工程指示 / 要求簡箋(E.I.)

工程指示編號：EI / 5635 / 23

工程名稱：將軍澳日出康城 11

工程項目：幕牆 收口鋁板 大貨 (加工圖修改)

工程號	J858	類別		物料號	-
地盘	康城11期	制圖	W. E. X	2022-08-11	圖號 AQ-14
修改	-	採用工廠			數量 -
日期	-	材料颜色	PVF2 (香檳金)	材料	3.0mm 铝板
		批准	-		單件重量 - (KG)

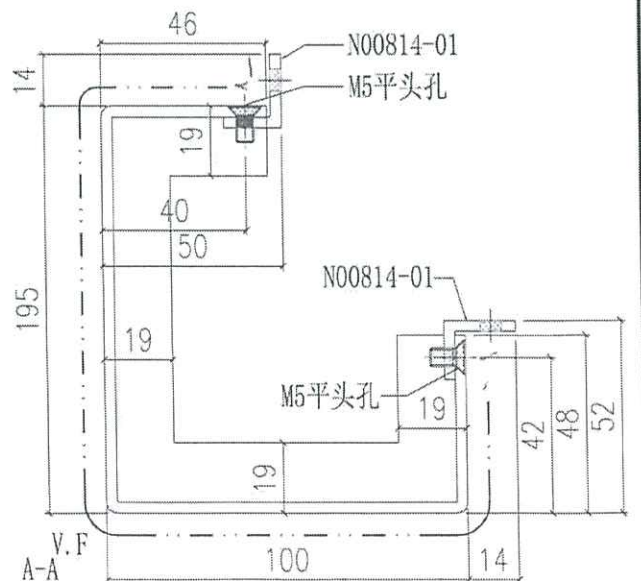
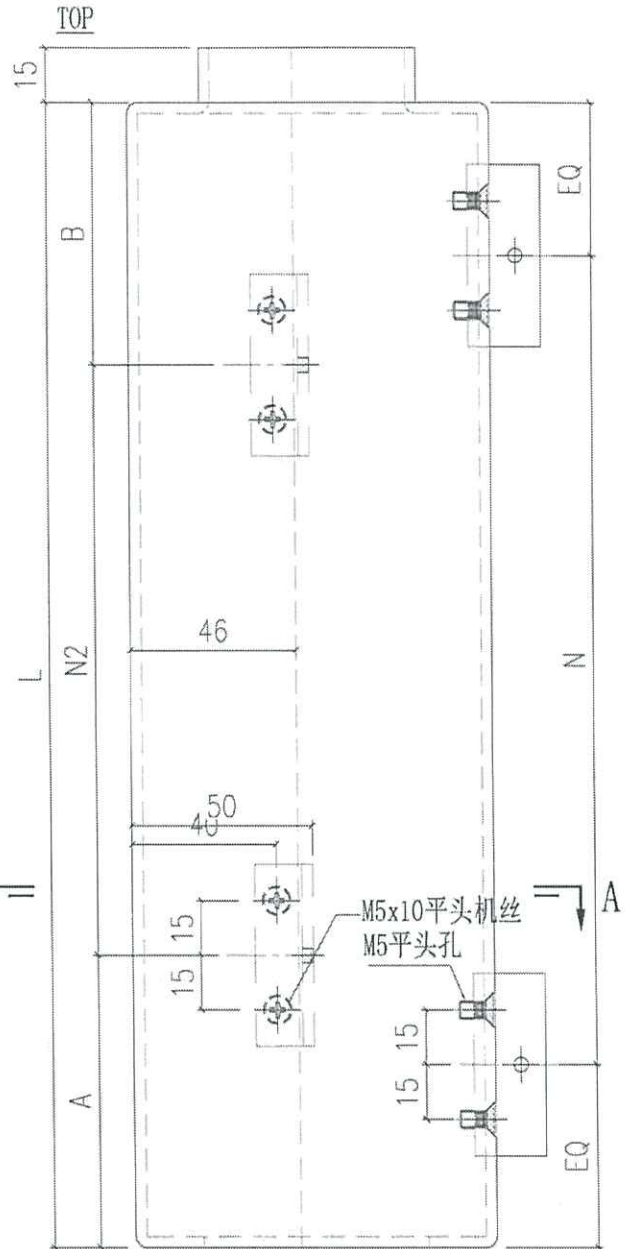
F 版：因應業主 Comment，轉角位置的顏色，先停噴色 AQ-14,15,19,20,37。

美特鋁質有限公司 MIDI Aluminium Fabricator Ltd.			工程號 J858 地盘 康城11期	類別 制圖 W. E. X	物料號 - 2022-08-11	圖號 AQ-37
修改 - 日期 -	採用工廠 材料颜色 PVF2 (香槟金)	地盤 <input checked="" type="checkbox"/>	图纸名称 铝折件 材料 3.0mm 铝板	復核 - 批准 -	數量 - 單件重量 - (KG)

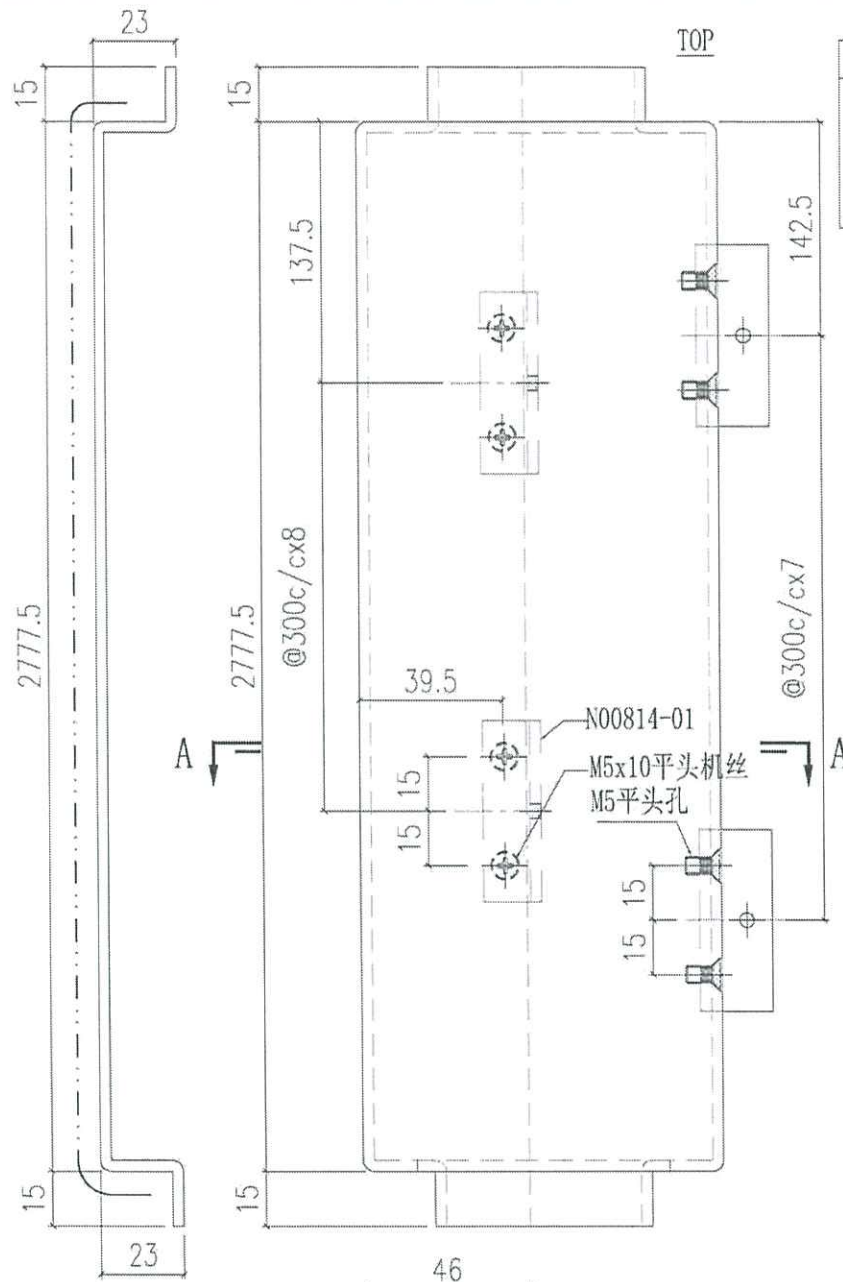
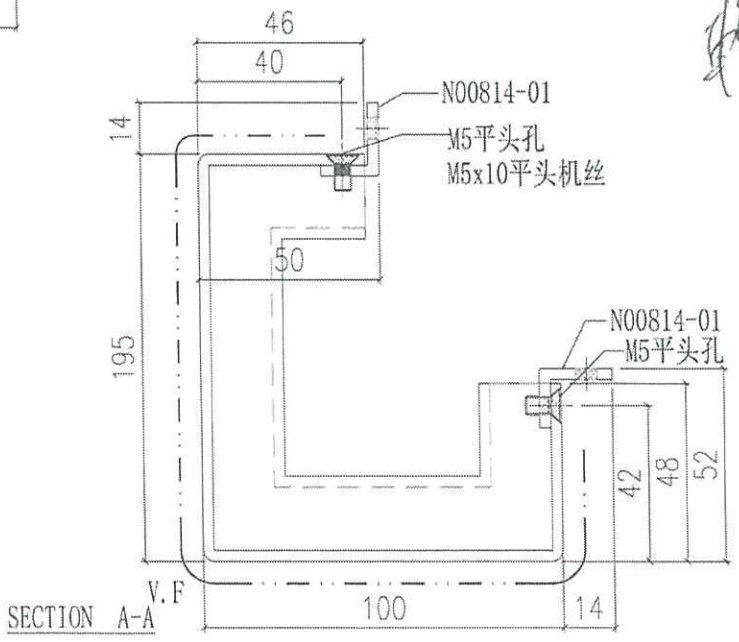
暫停  
噴塗

轉角
